**RE: AGL Energy Limited Newcastle Gas Storage Facility – Storm Water Management Peer Review Part 1: Design Modelling**

Hunter Water Corporation has requested that SMEC Australia Pty Ltd undertake a peer review of the Storm Water Management Philosophy and Detailed Design of the Newcastle Gas Storage Facility (NGSF) situated in Tomago and Hexham in the NSW Hunter Region. WorleyParsons have conducted the previous modelling and design work on behalf of AGL Energy Limited (AGL) as a result of considerable consultation with a number of parties due to constraints on the disposal of stormwater on the site.

**Figure 1** – MUSIC Schematic (WorleyParsons, 2010)

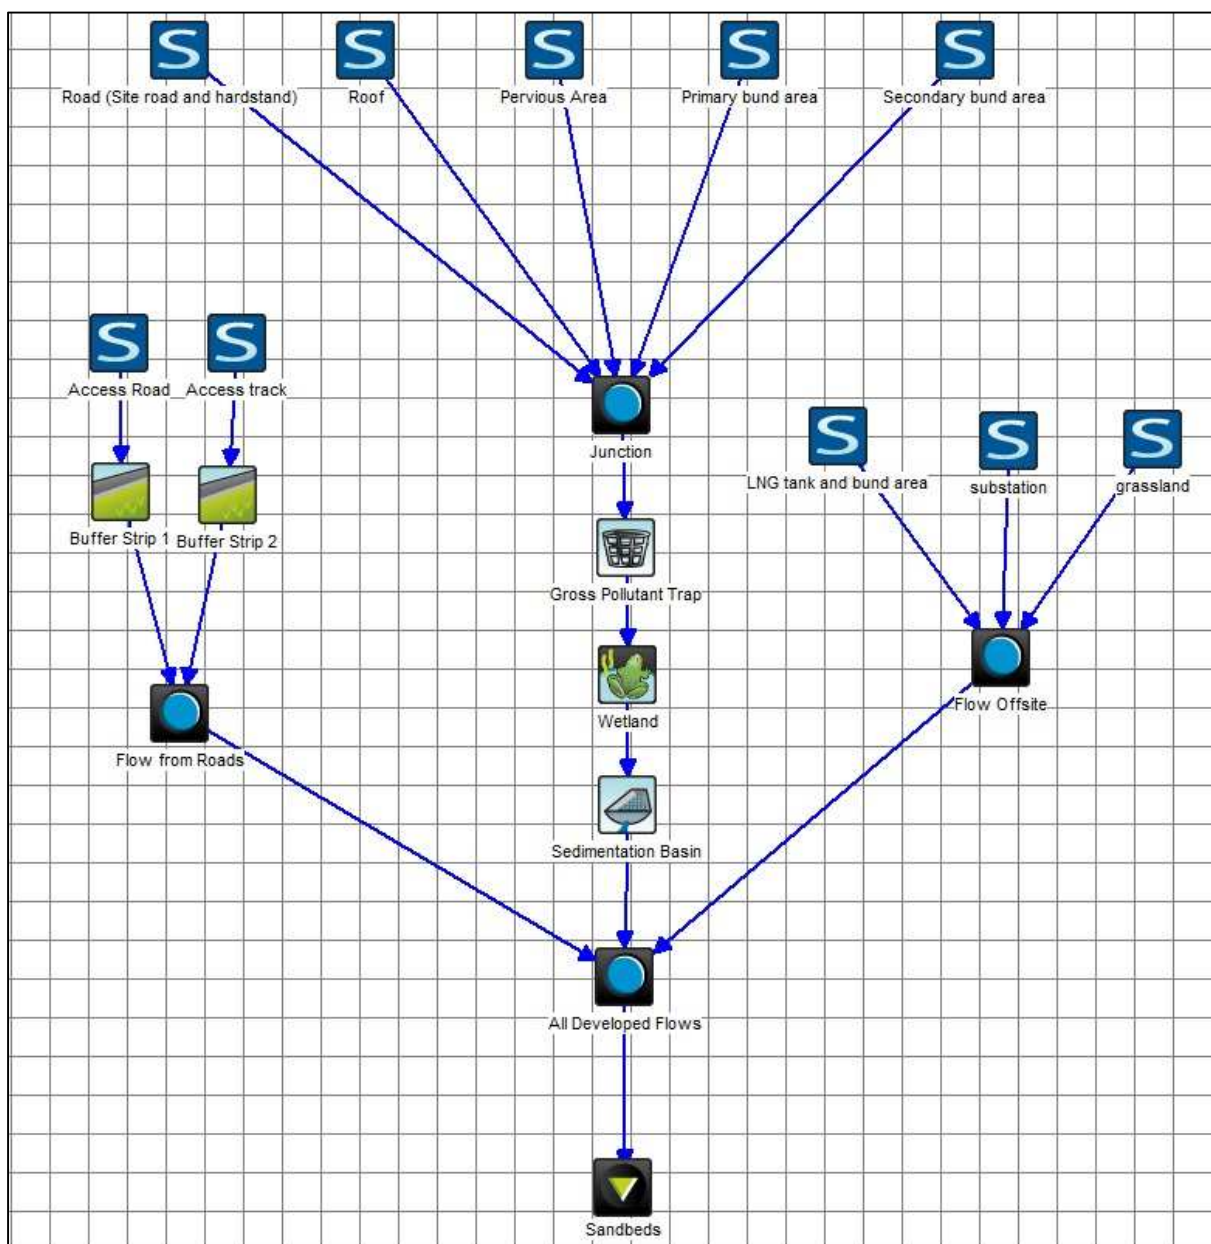
It may be noted in **Figure 1** that the receiving waters are labelled as “Sandbeds.” This node has no properties other than the purpose of outputting results. As such, this is simply a graphical error that has not been modified along with the design changes and does not affect the previous model results.

**Figure 2 –Comparison of DRAINS and Water Balance Modelling Results**

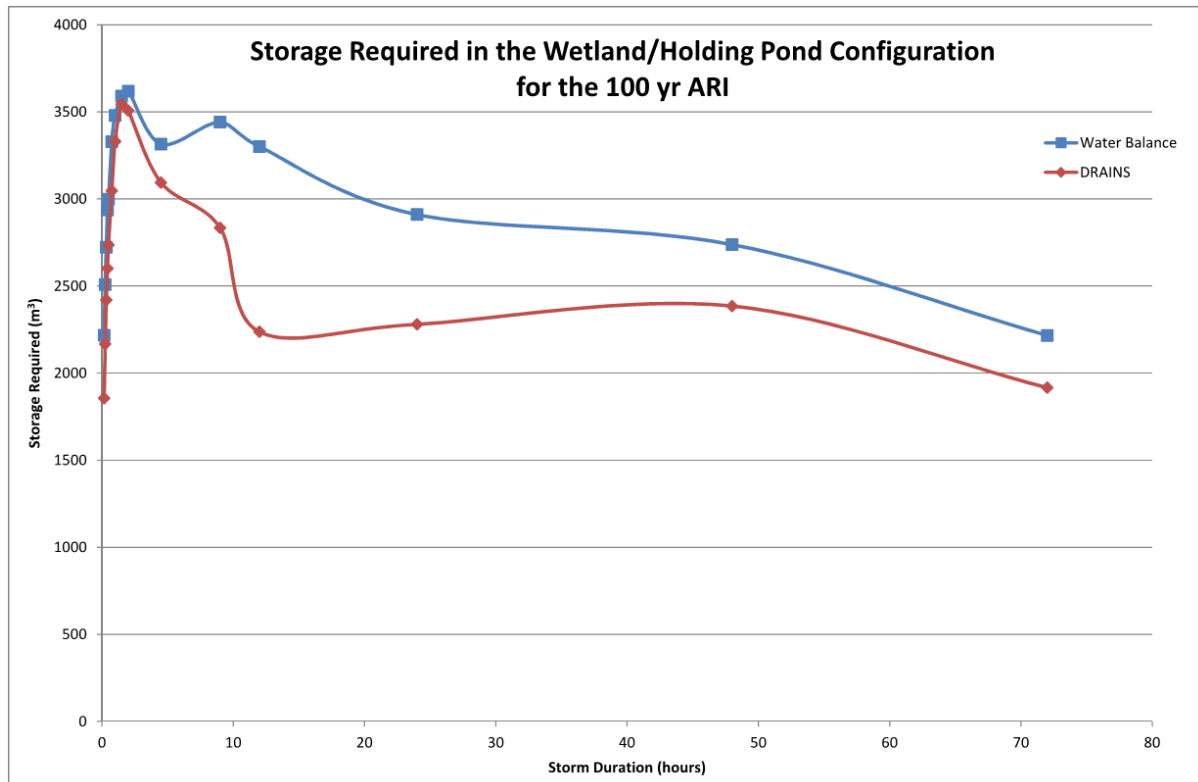
**Figure 2** compares the results of the Water Balance and the DRAINS model for the 100 year ARI for a range of storm durations. The peak storage calculated in the model is 3544m<sup>3</sup>, which contains the 1.5 hour duration storm. Comparatively, the peak storage calculated in the Water Balance model is 3619m<sup>3</sup>, which contains the 2 hour storm duration.

**Figure 2** displays a reduction in storage required with the increase of storm durations. This is due to the pump outflow of the storage system, which can withdraw larger volumes over a longer duration. The Water Balance results show a slower decay in storage required, as continuing losses in the model are fixed and are conservative. The DRAINS model assumes a non-linear rate of groundwater infiltration as it accounts for the rate of soil moisture uptake as a function of the soil moisture storage.

The difference in peak storage results between the models are considered negligible as they are in the order of 2-3%, verifying that the DRAINS modelling is sufficient for assessing the storage required for the storm water management plan.

A more conservative approach, such as the water balance model, may be beneficial as it may be noted in **Figure 2** the change in volume of the longer duration storms is significant between the two models. The models assume that pumping occurs at the full capacity of design. If this is not the case and some pump efficiency is lost, the maximum storage required could easily be governed by a longer duration storm such as the 12hr event in the water balance model. It is recommended that WorleyParsons adopt a conservative approach similar to SMEC and simulate some lower pump efficiency scenarios to account for this.
